Serial No.: 09/477,790 - 8 - Art Unit: 2123

#### **REMARKS**

In response to the Office Action mailed July 8, 2003, Applicant respectfully requests reconsideration. To further the prosecution of the application, amendments have been made in the claims, the written description, and the drawings. The application as presented is believed to be in allowable condition.

FIG 3

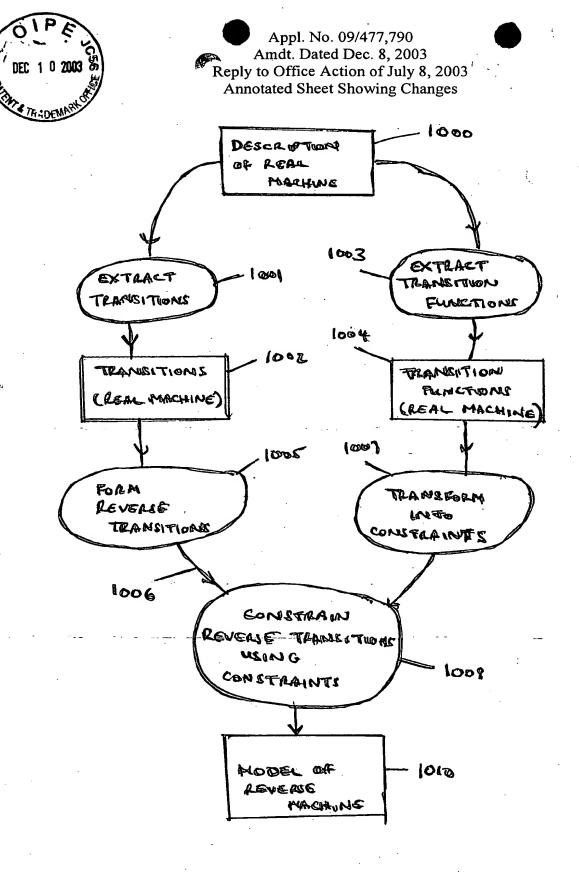
In response to ¶ 3 of the Office Action, Applicant has modified Figure 3 to address the Draftsperson's objection that the lines, numbers and letters were not uniformly thick nor well defined. The line quality of Figure 3 has been improved to overcome the Draftsperson's rejection. No new matter has been added by this change. Applicant encloses a "Request for Corrections, Approval and Entry of Drawings" letter requesting the replacement of Figure 3 with the drawing in the Appendix of this response.
